Bern, 13-17 March 2017

**Tanks****Tanks with a section including a concave part —  
Interpretation of 6.8.2.1.18**

Transmitted by the Government of France\*,\*\*

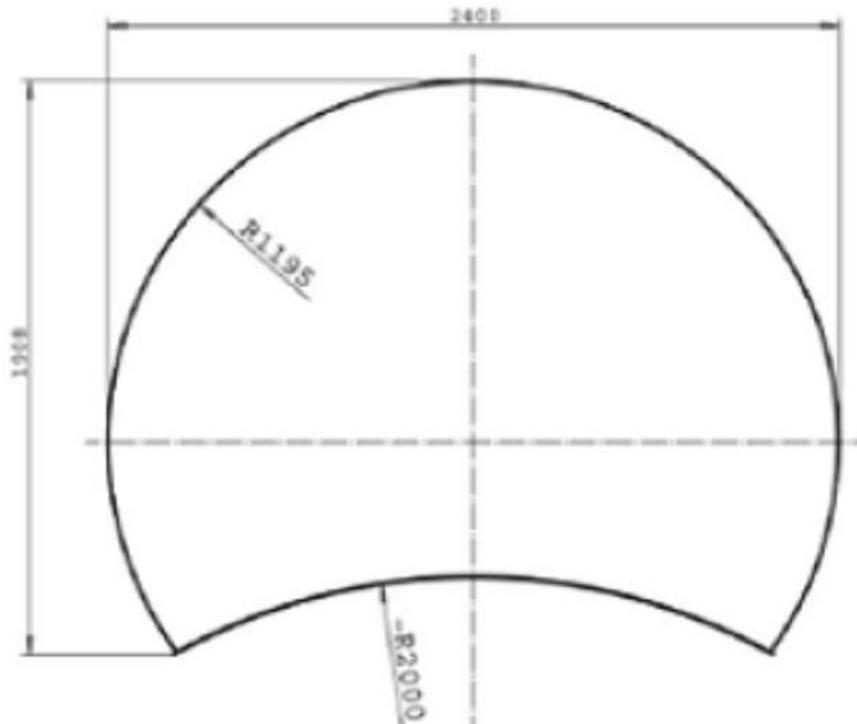
4. In our opinion, this type of construction cannot comply with RID/ADR for the reasons given below.
5. The hybrid cross-section shown in paragraph 1 cannot be considered to be a circular or elliptical cross-section; consequently, it is of another shape for the purposes of RID/ADR.

6. For shells not of a circular cross-section, footnote 2 to 6.8.2.1.18 of ADR requires that the radius of convexity of the shell wall should not exceed 2,000 mm at the sides or 3,000 mm at the top and bottom. The shape proposed is bounded on its lower part by a concave radius and thus does not comply with this requirement of ADR.

7. Moreover, under standards EN 13094 and EN 14025 on the design and construction of tanks:
  - EN 13094, in 6.3.1, requires a minimum radius of 200 mm linking the top/bottom and side convexities. There are no joints between side and bottom convexities and so this requirement of the standard is not met;

- For the calculation for construction types not given in EN 14025, 6.3.1 of that standard refers to the provisions of EN 13445-3, meaning that the manufacturing requirements of EN 13445-3, and specifically the types of weld joint allowed for shell longitudinal and circular welds, must be met. According to tables A-1 and A-2 of EN 13445-3, fillet welds are not allowed for shell longitudinal or circular welds; hence, this requirement is not met.

8. We therefore consider that this type of construction does not comply with regulatory and normative requirements and therefore cannot be used for the transport of dangerous goods.
  9. We would like to know the opinion of the Joint Meeting on this matter.
-
